ADDENDUM #08

INVITATION TO BID #01

ACES at CHASE

STATE PROJECT NO. 244-0044 MAG

A731-4

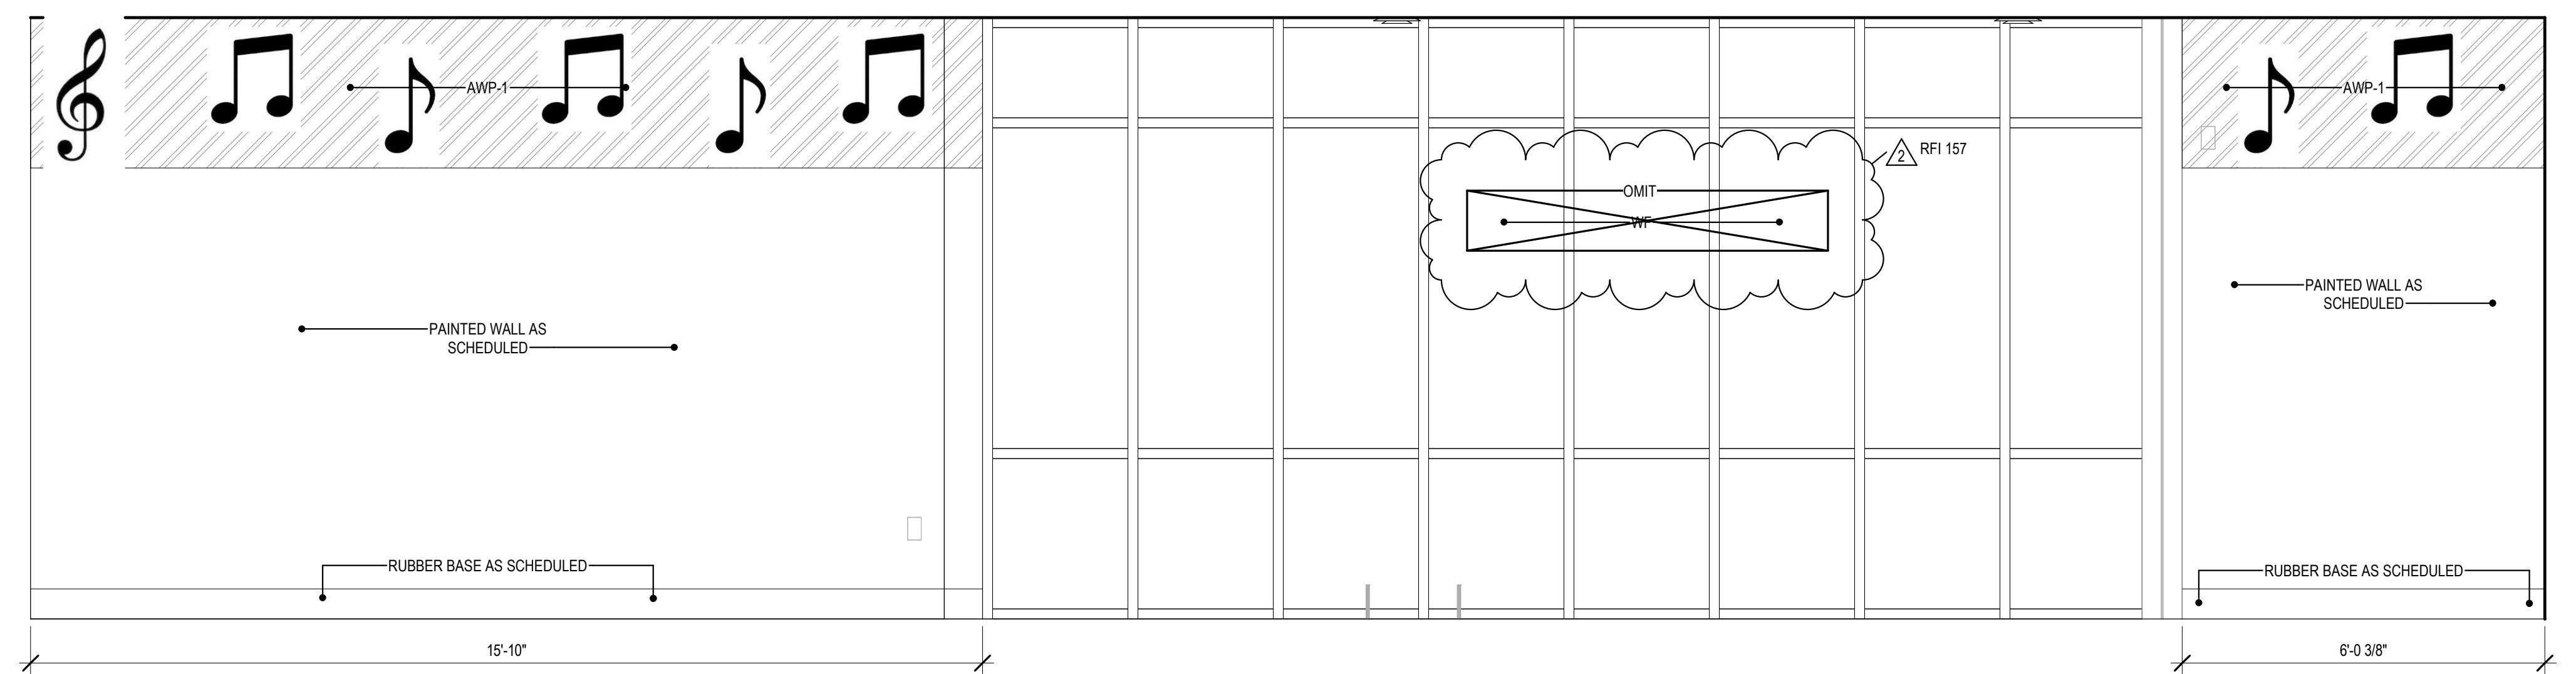
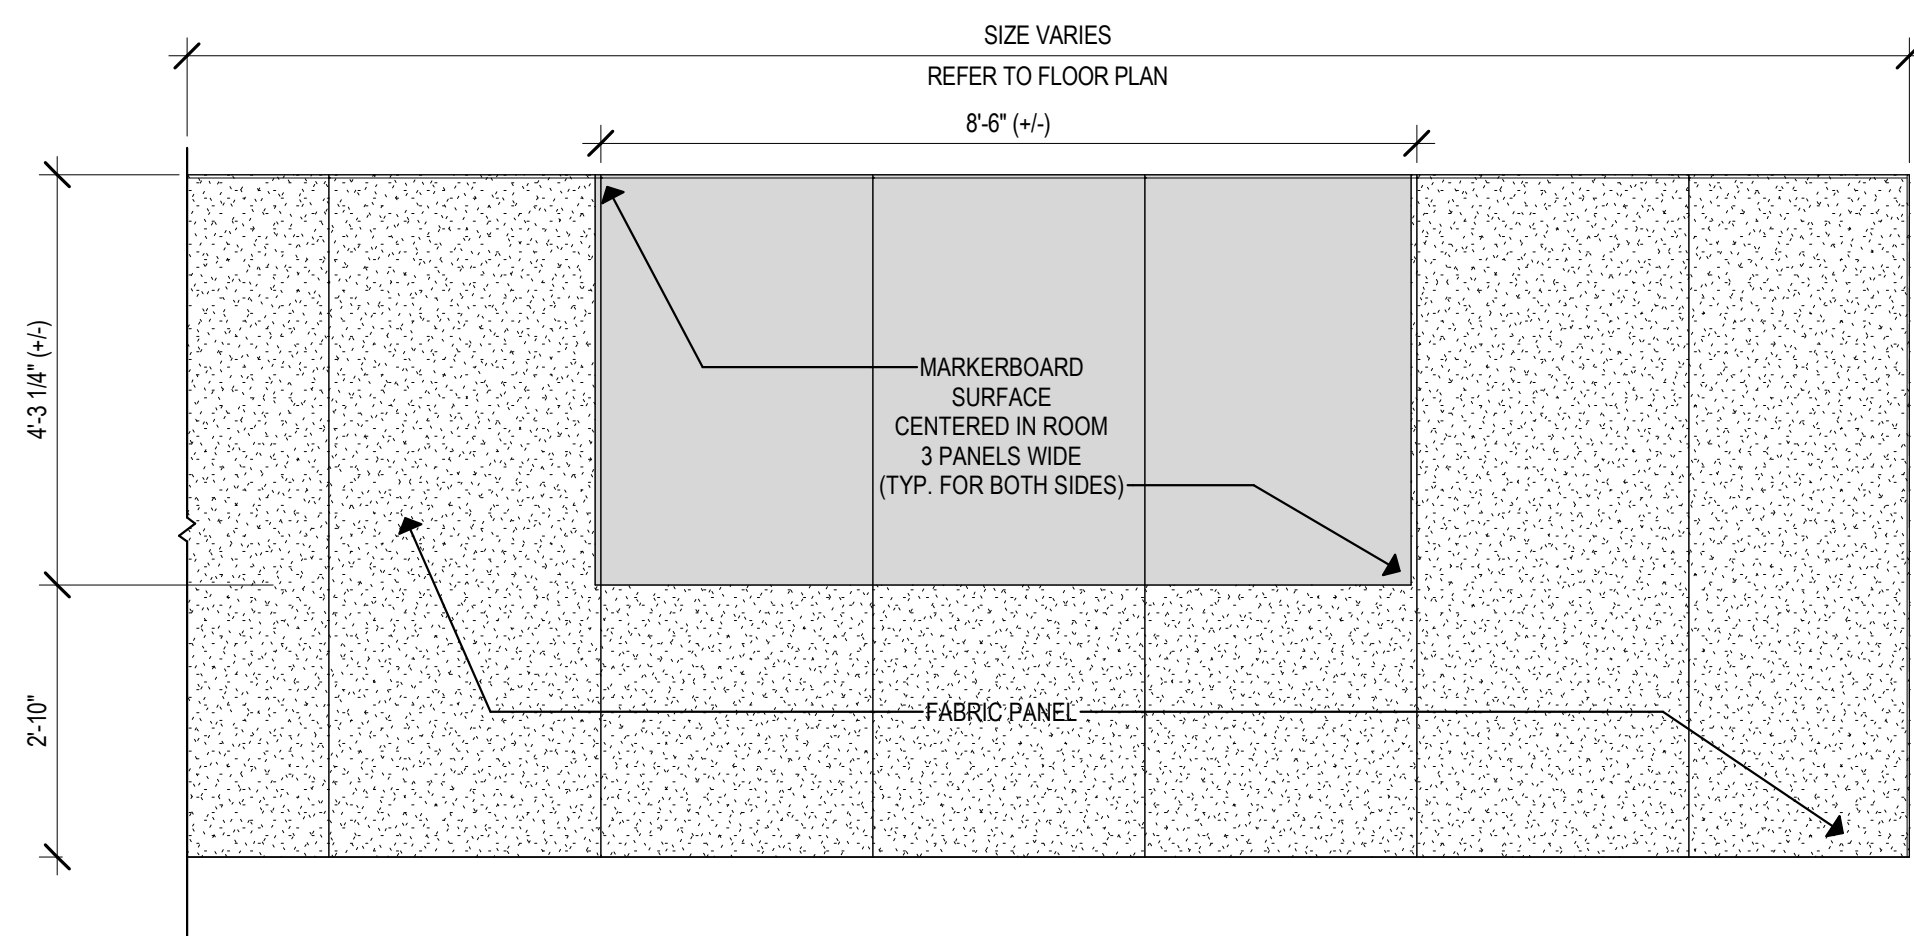
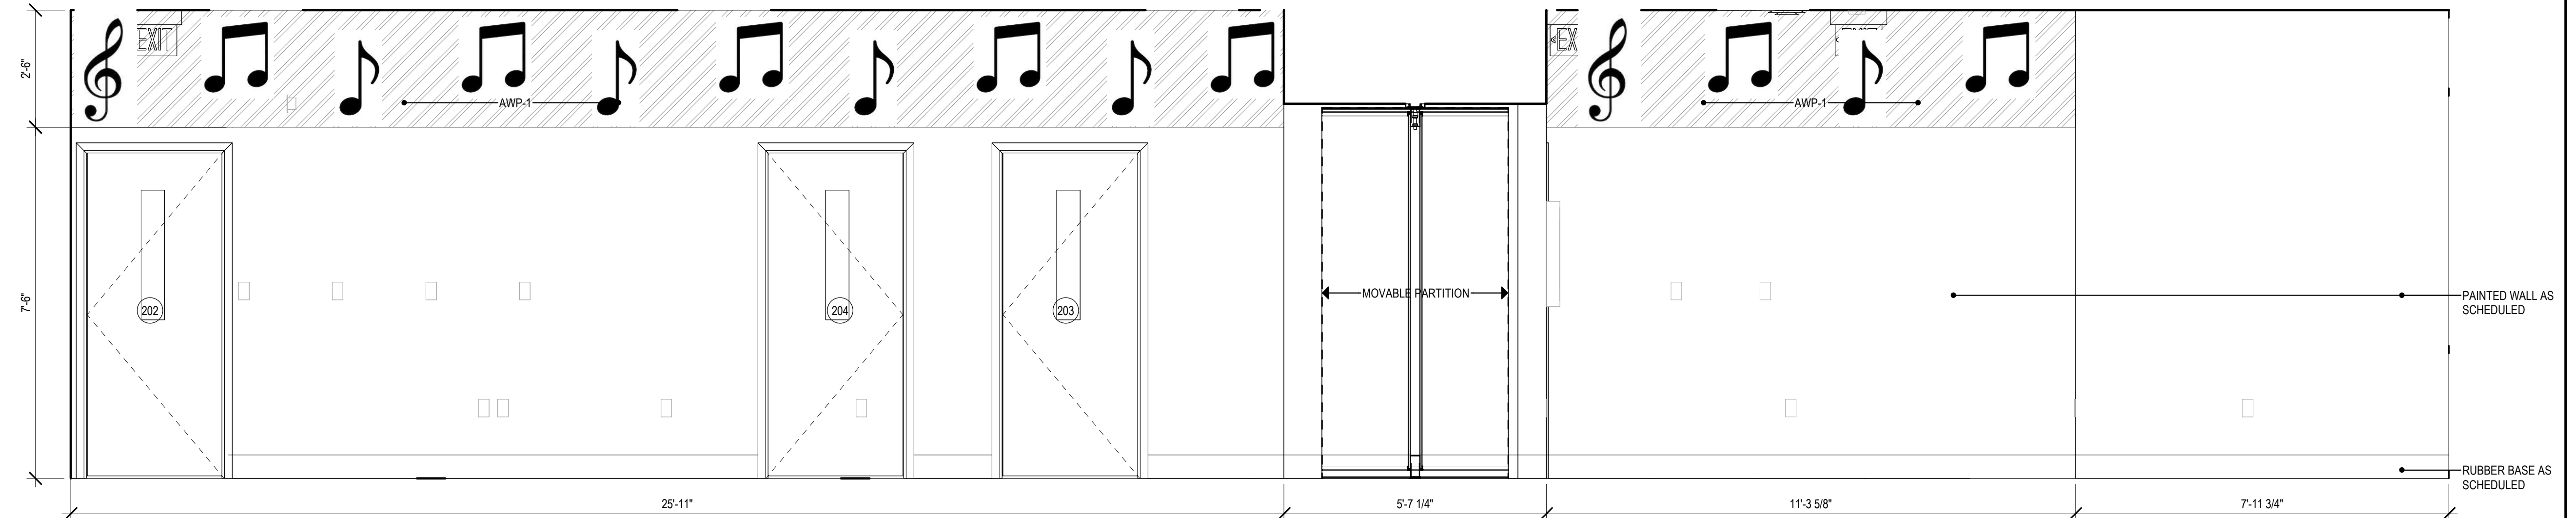
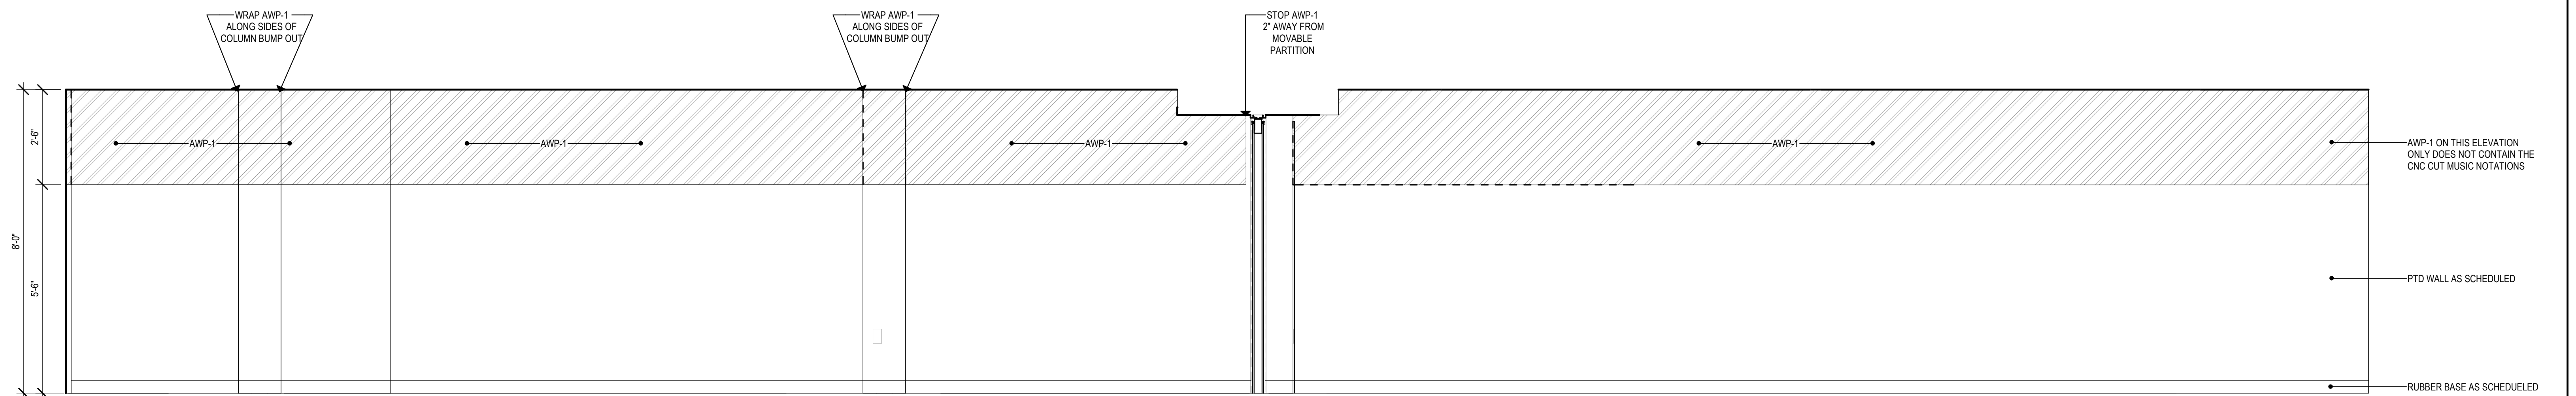
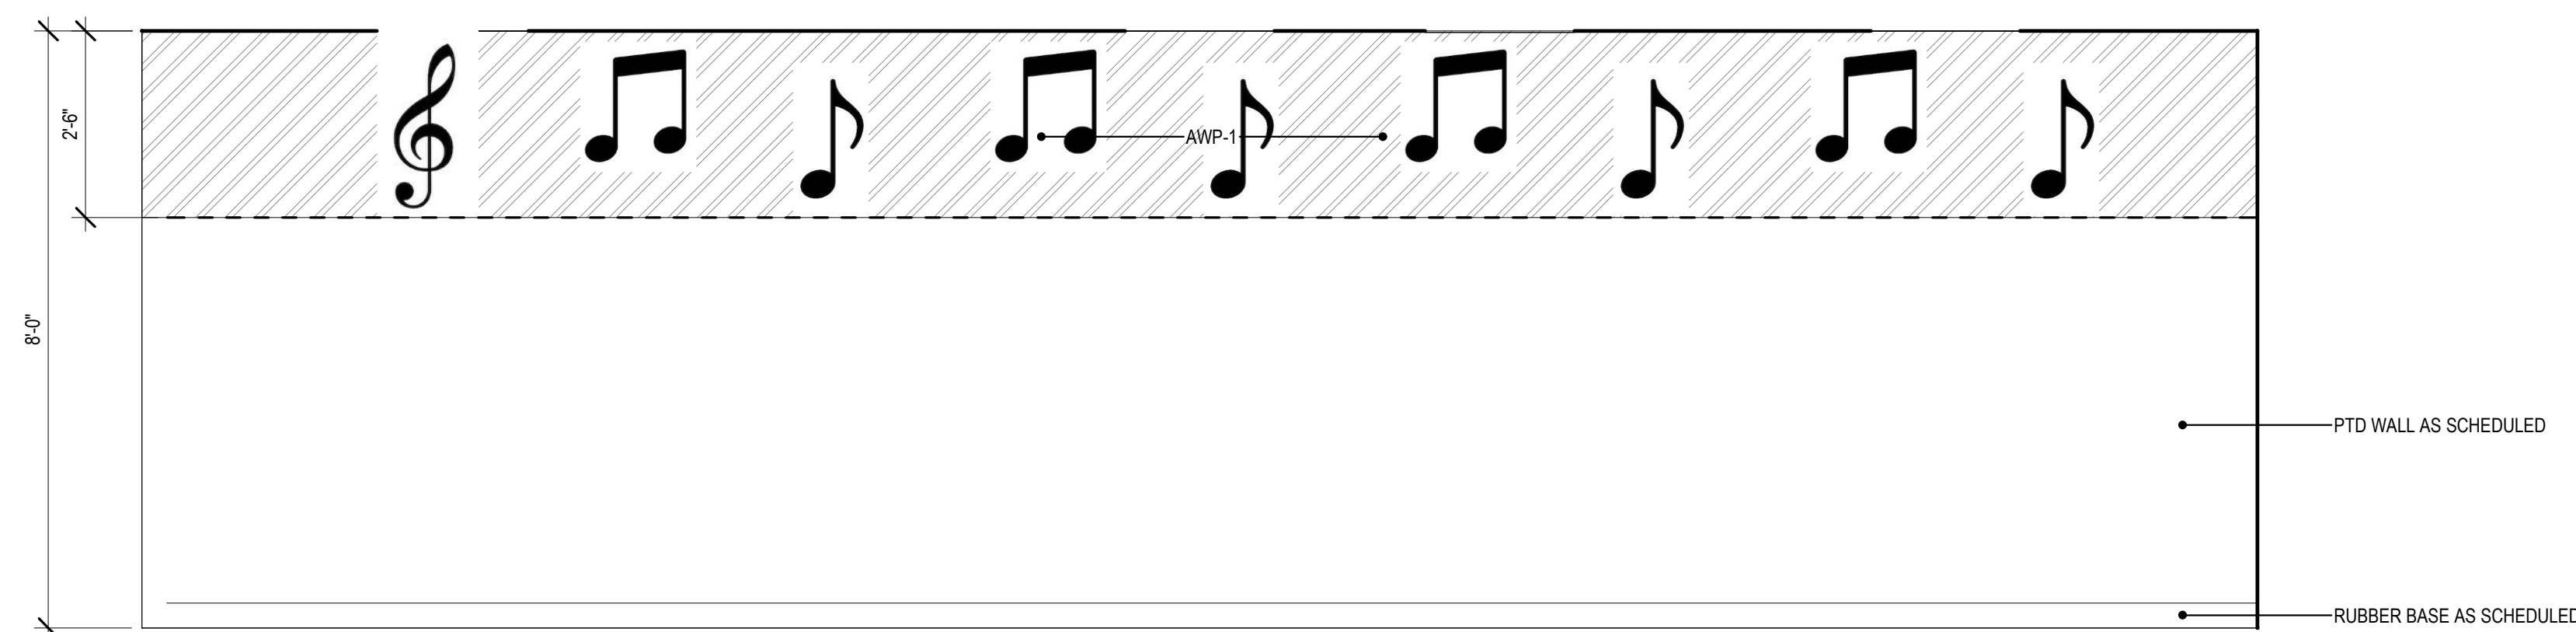
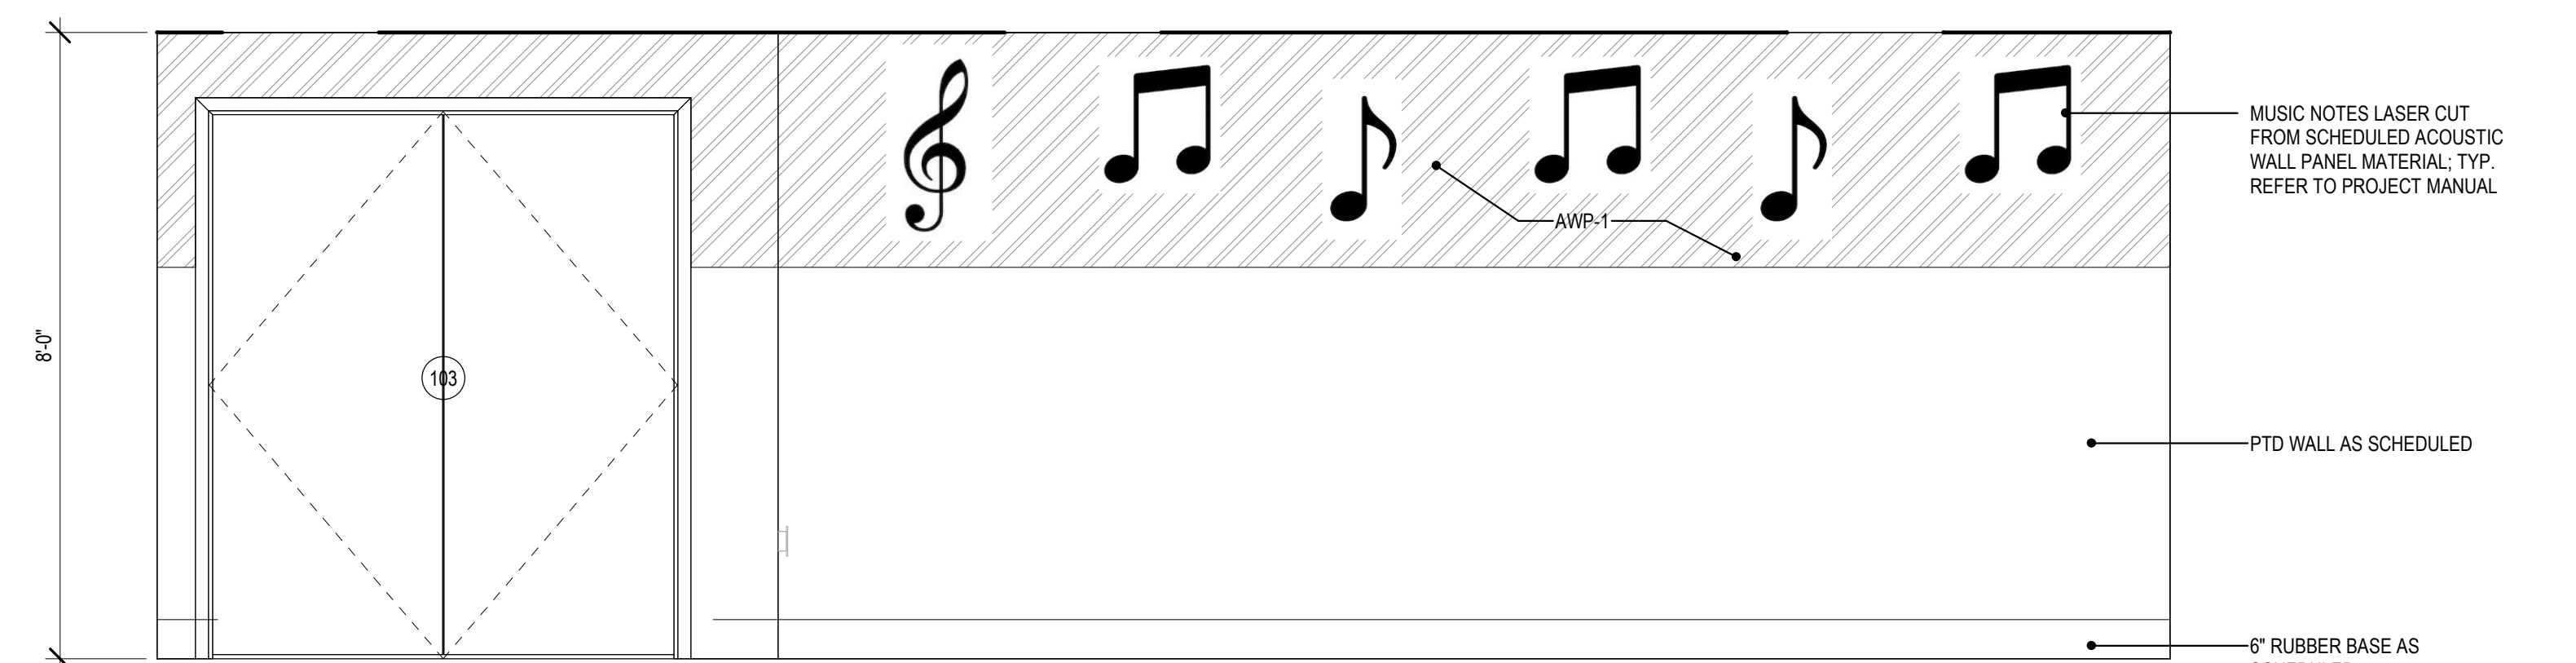
- Building #2:
 - DRAWING A731-4, BUILDING 4 – INTERIOR ELEVATIONS, delete in its entirety. A new Drawing A731-4 has been added and is attached as part of this bulletin.* *(Per RFI #157)*
